ADDENDUM #2

CTE Renovation and Misc Improvement North Knox Jr/Sr High School

The original bid documents and drawings dated September 23, 2025, for the aforementioned project are amended as noted in this Addendum for the purpose of correcting and/or clarifying the original bid documents and drawings and shall take precedence over them. These changes and all incidental items required to provide the following corrections and/or clarifications shall be included even though not specifically described and shall become a part of the Contract Documents. This Addendum is to be sent to all bidders receiving bid documents and drawings and receipt of this Addendum is to be noted by each bidder in their bid proposal.

A7

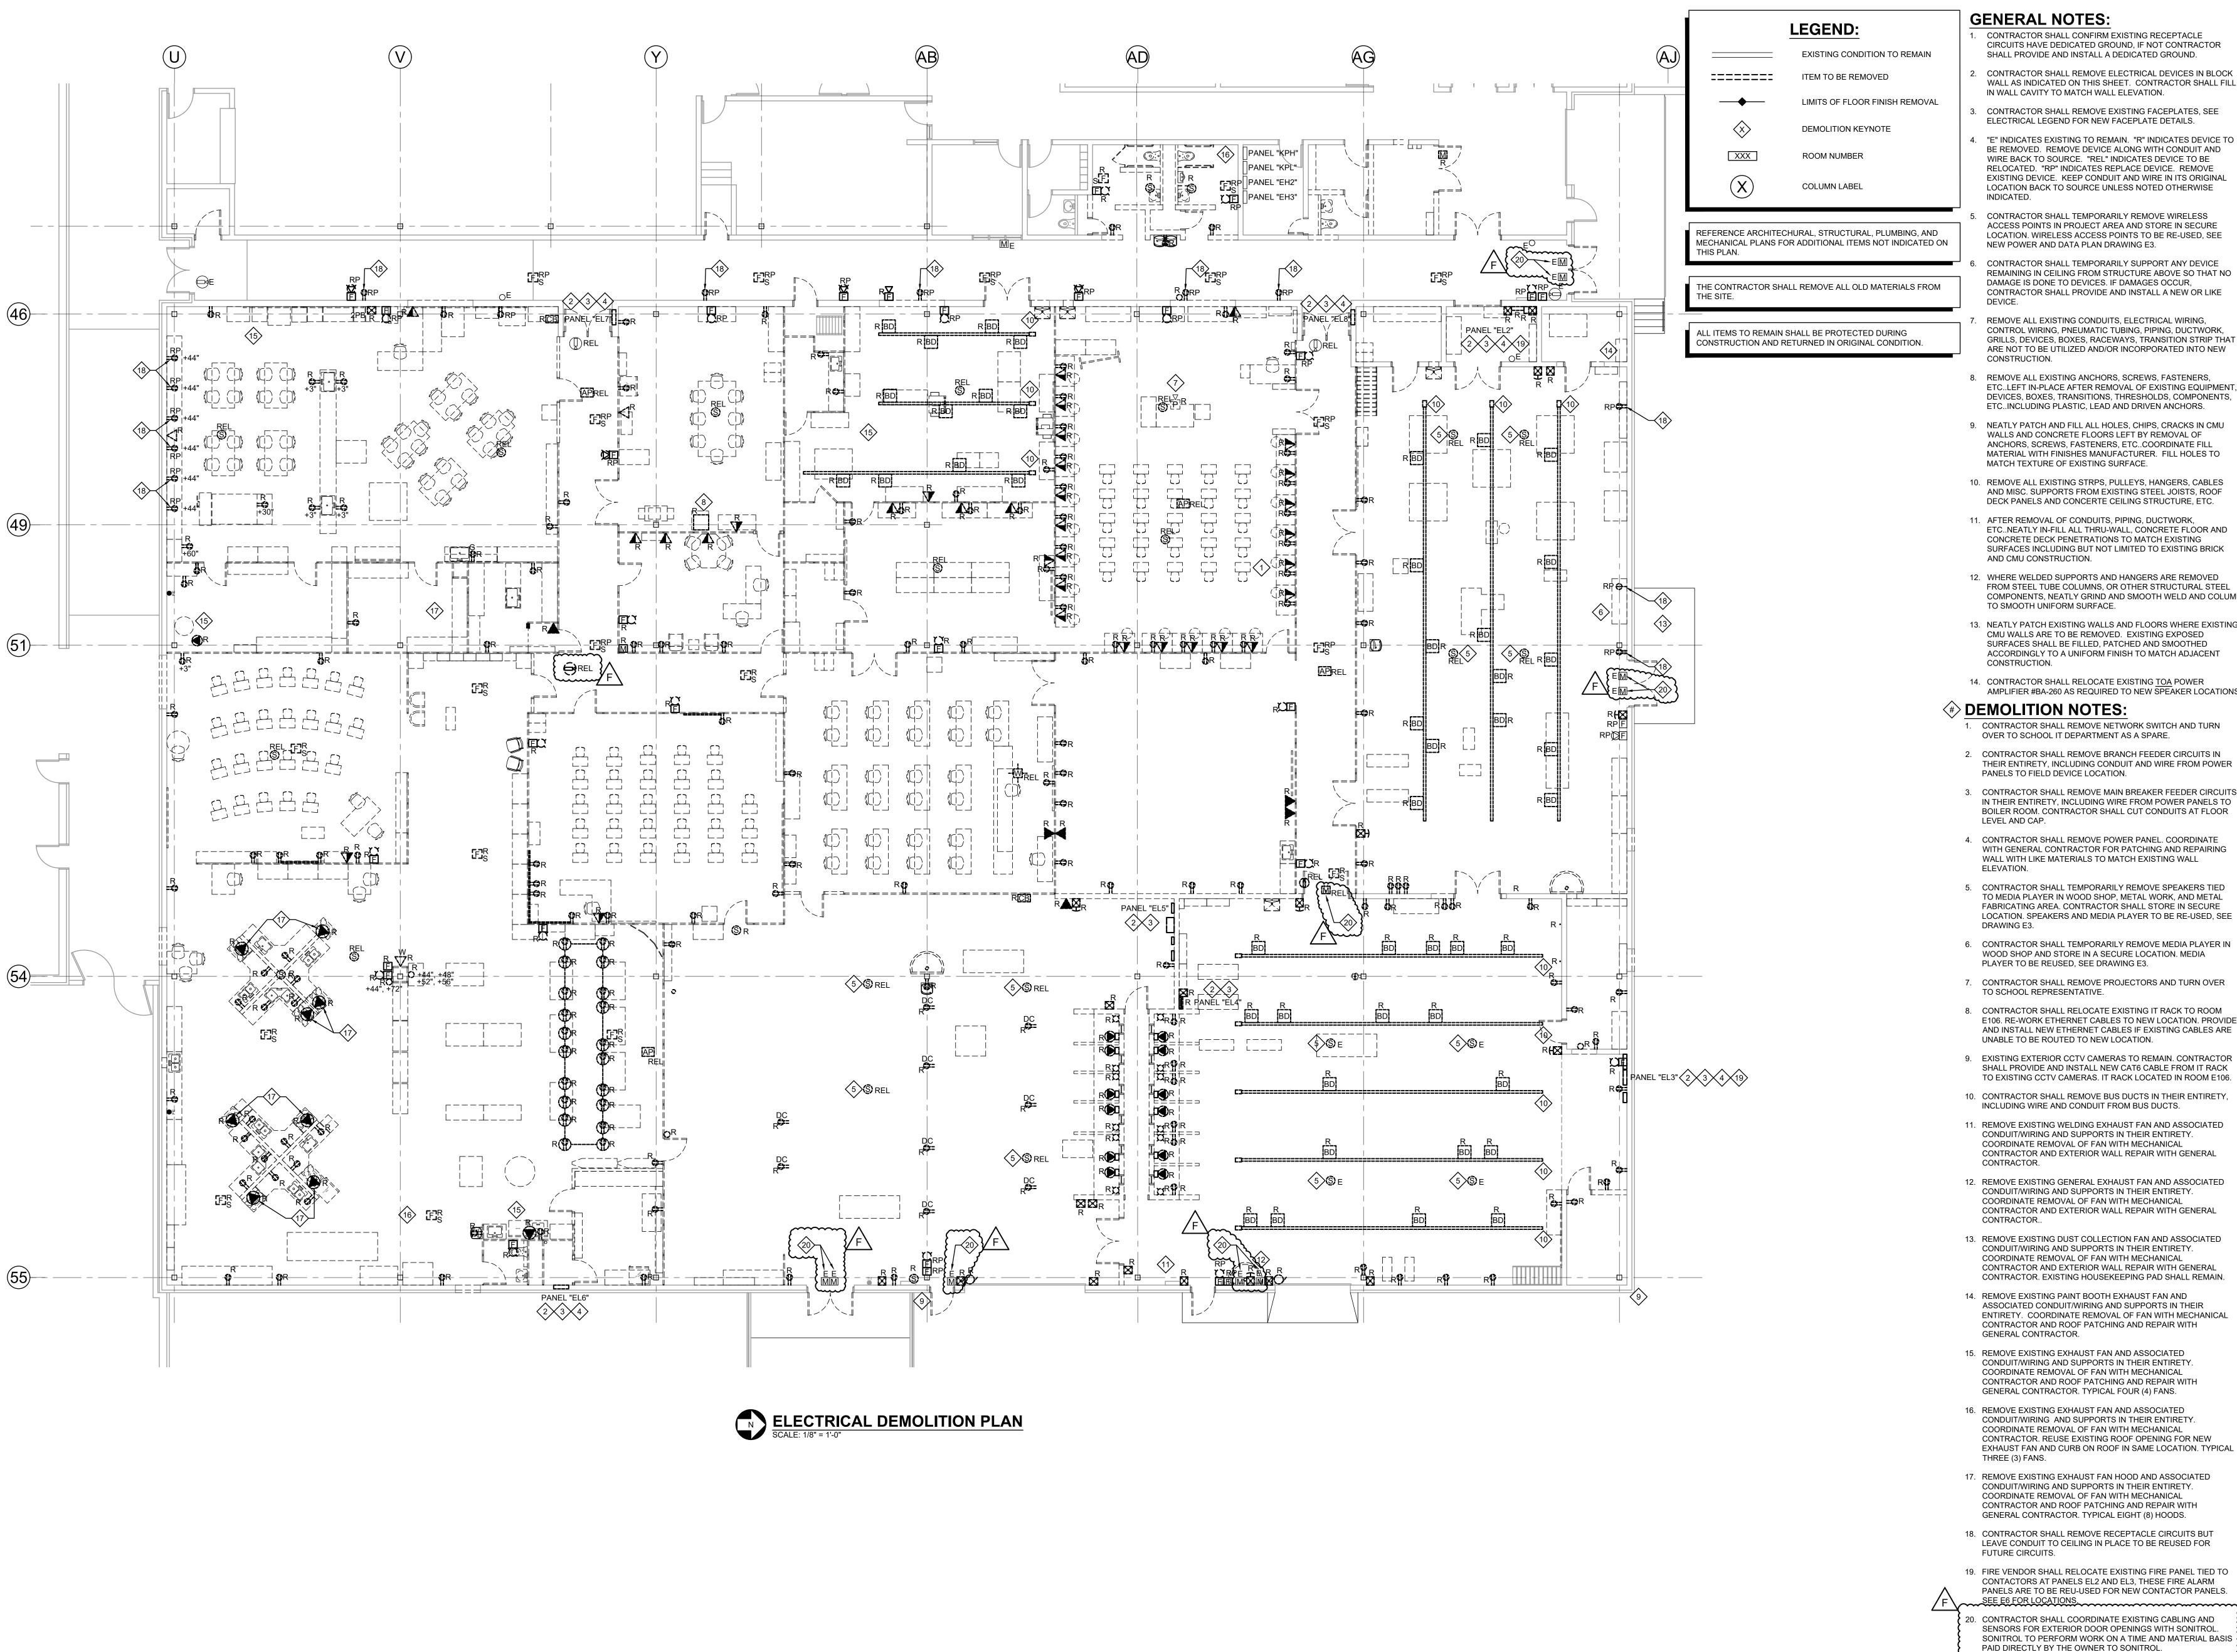
- 1. Bidder question "There is a minimum order for each color/style on the Artform panels. The current design shown does not show that minimum. Do you still want to include this in the bid?"

- Answer Please submit your bid to include the minimum. Sheet A7 has been modified to include installation of the additional panels in the Interview #2 and Broadcasting rooms.

DEMOLITION PLAN

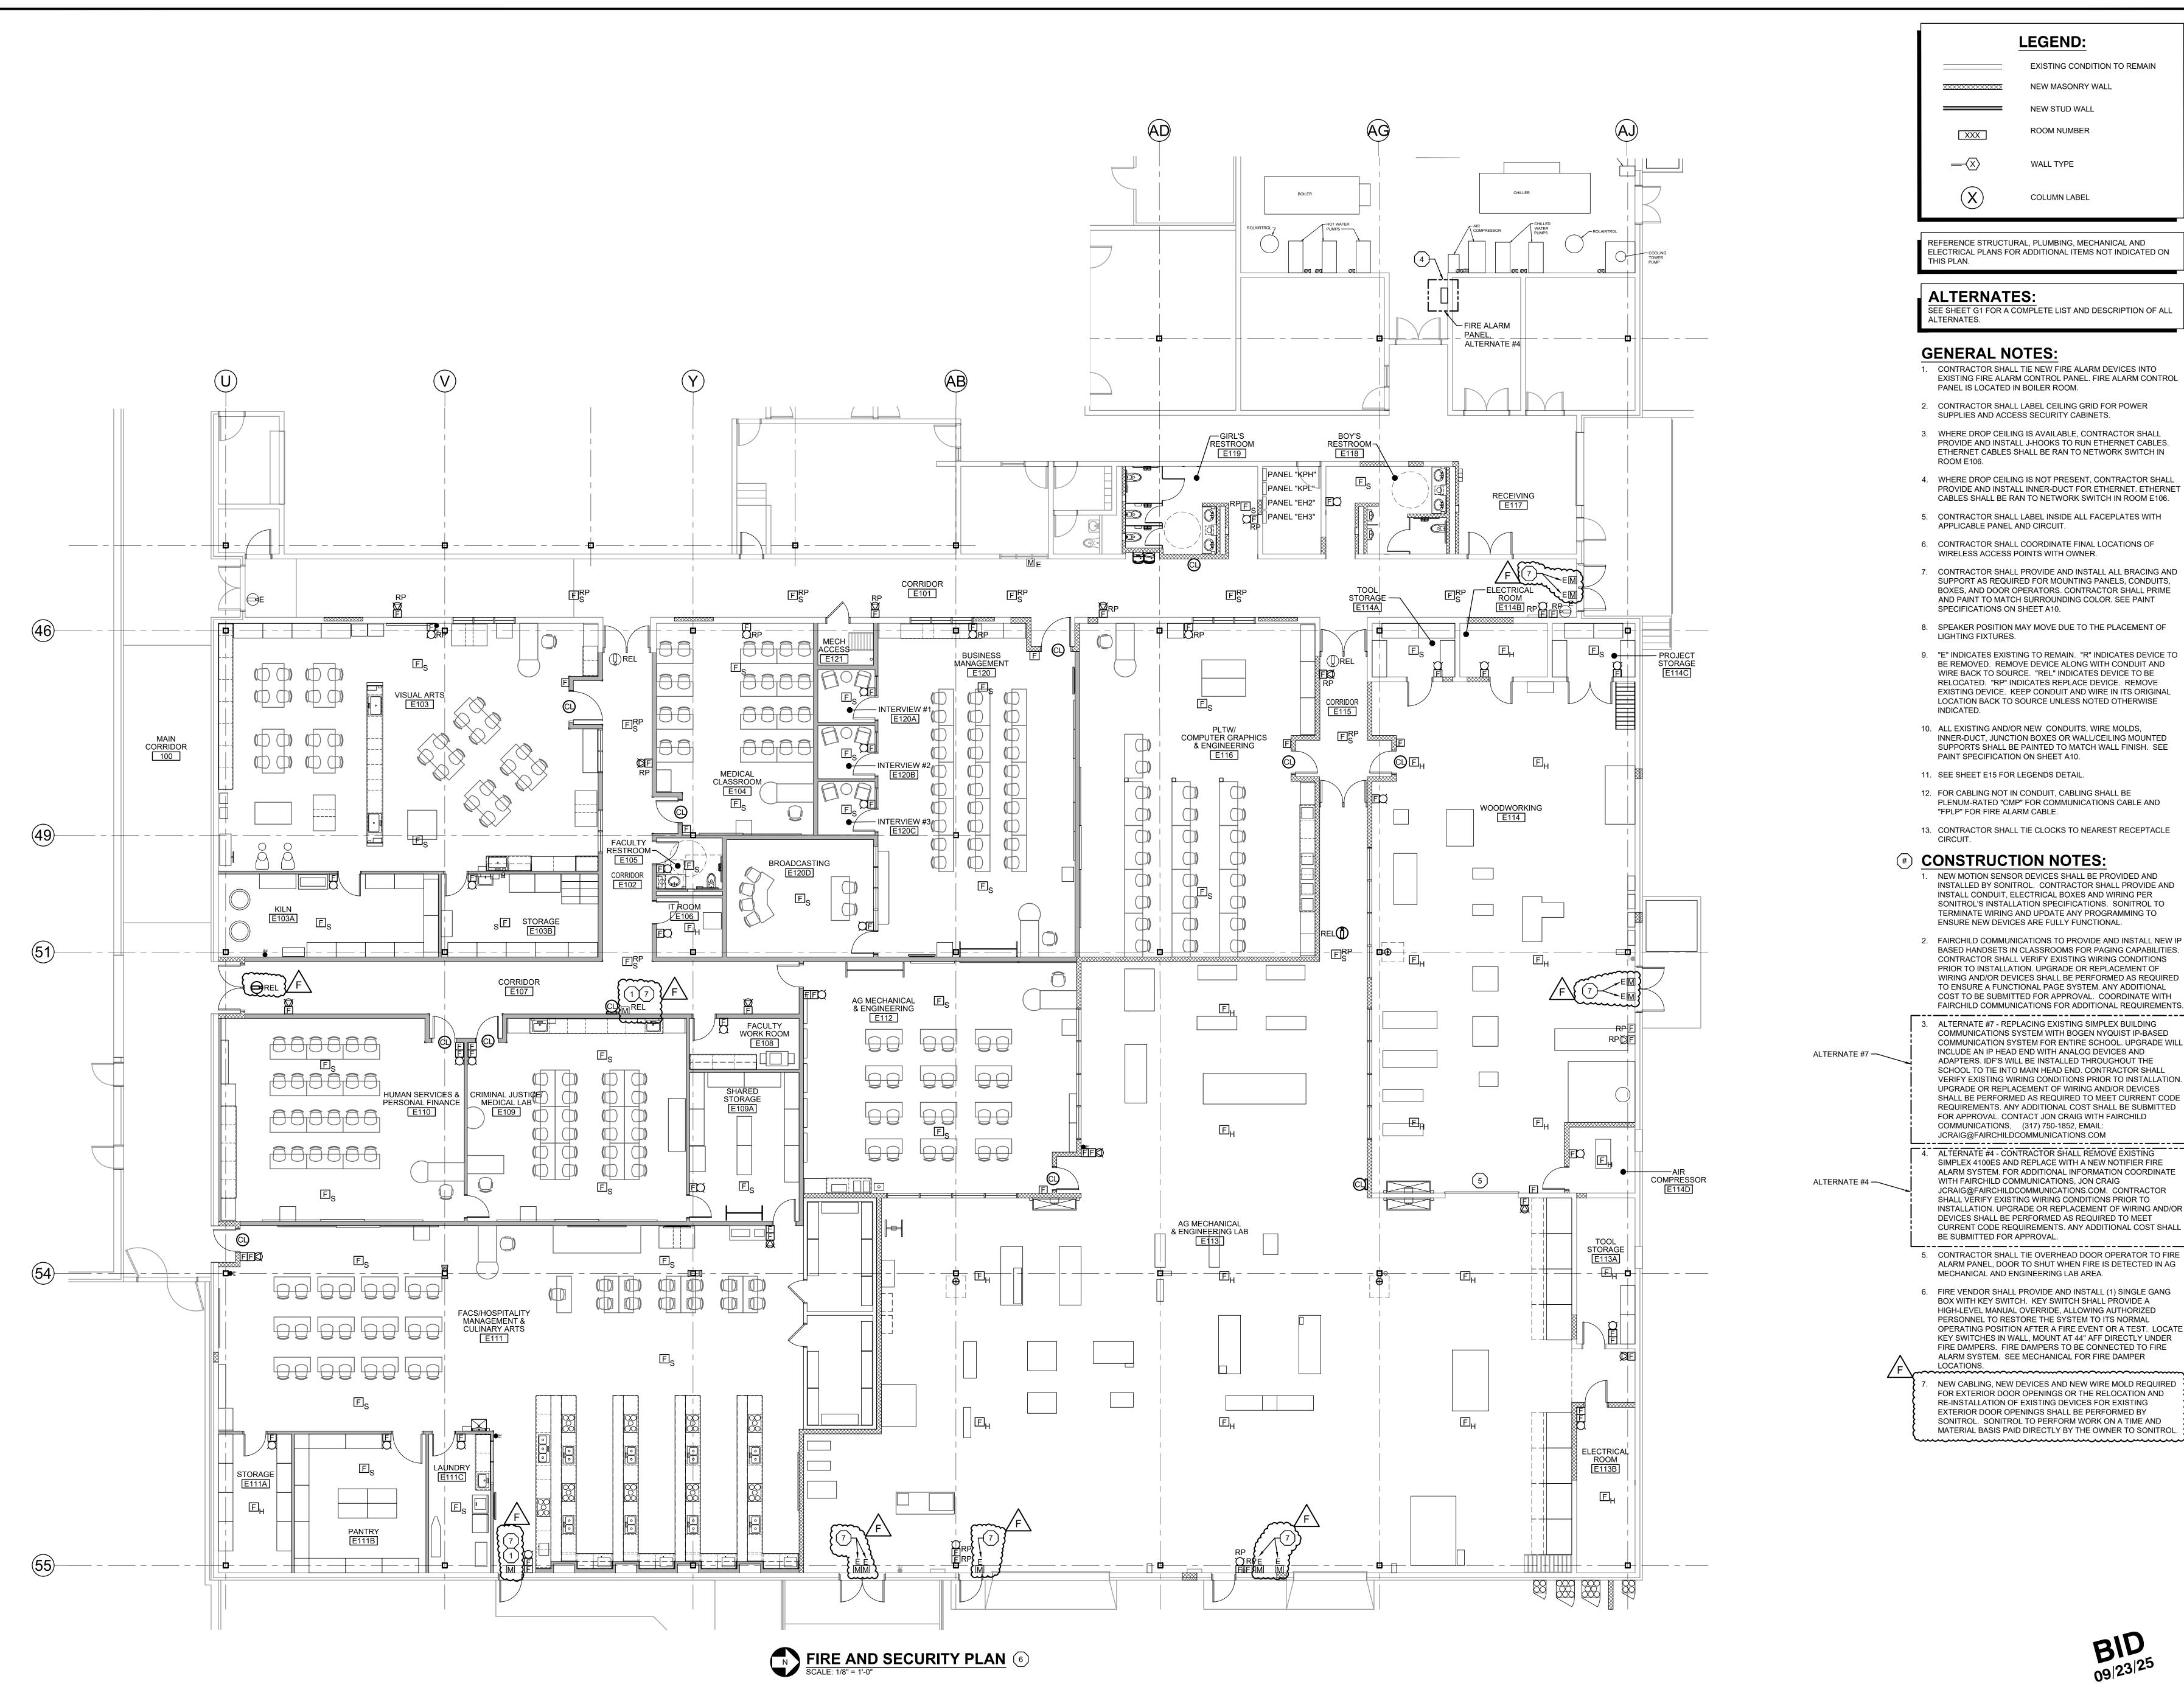
- 5. Bidder question "Per the drawings, we are to relocate the existing 2-post rack with the existing horizontal and backbone cabling included, for bidding purposes, are we to assume all cabling will reach the new destination? If not, will a drawing be issued showing the path of the existing backbone cable and the number of horizontal voice/data cables to be replaced?"

- 6. Bidder question "There is a camera that is at the end of a hallway that has icon of 180 degree. Can you confirm if the school is wanting to change the existing camera that is there to a 180-degree camera?"

- Answer Yes, the existing IDF-E 2-post rack is to be relocated to new location. Unfortunately, there is no map or list of IDF-E for ethernet cabling ran to equipment or devices outside of project area which will need to be extended to new IDF-E location via couplers ensure same category rating. If horizontal ethernet cabling is in the project area, cabling shall be removed and new ethernet cabling installed to new rooms/devices as shown on drawing.

Answer – The camera with the 180 degree icon is located at the end of Corridor E107. This is a new hallway so there is not an existing camera at this location. However, further review of the field work located one near the door to the existing FACS area. This has been updated to be relocated to Corridor E107.
